Blue Phoenix

Tilbury IBA

Impervious liner - Independent review

Figure 1: Site plan

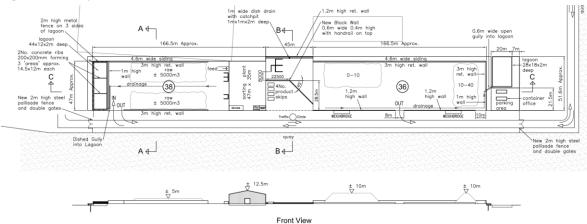
The site comprises external ash reception areas 36 and 38 either side of a centrally located IBA sorting building and product skip area, as shown in Figure 1. Lagoons at either end of the site are designed to capture rainwater and/ or leachate runoff from the adjacent ash reception area.

Fichtner has reviewed the as-built construction drawings provided by Blue Phoenix. From the drawings, Fichtner's understanding of the intent of the drainage design is that any rainwater and/or leachate run-off from the ash reception area is drained to the lagoons which are located at the low point of the hardstanding. Run-off water and leachate on the surface of the hardstanding flows by gravity to formed low points and is directed into the lagoons. Treated water from the lagoons is then discharged to a foul sewer at a controlled rate.

Figure 3: Hardstanding reinstatement detail

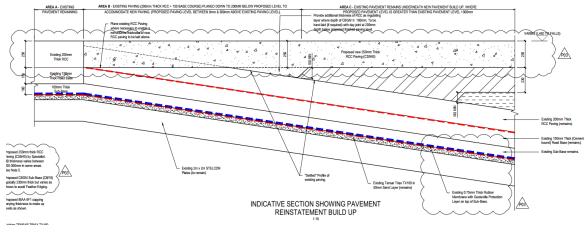
Information provided by Blue Phoenix indicates that remedial works were undertaken to the ash reception area in 2022 -2023 as the area had undergone settlement and been subject to wear to the hardstanding surface due to the ongoing operation of the Facility. The purpose of the remedial works was to raise levels and reinstate a roller compacted hardstanding surface.
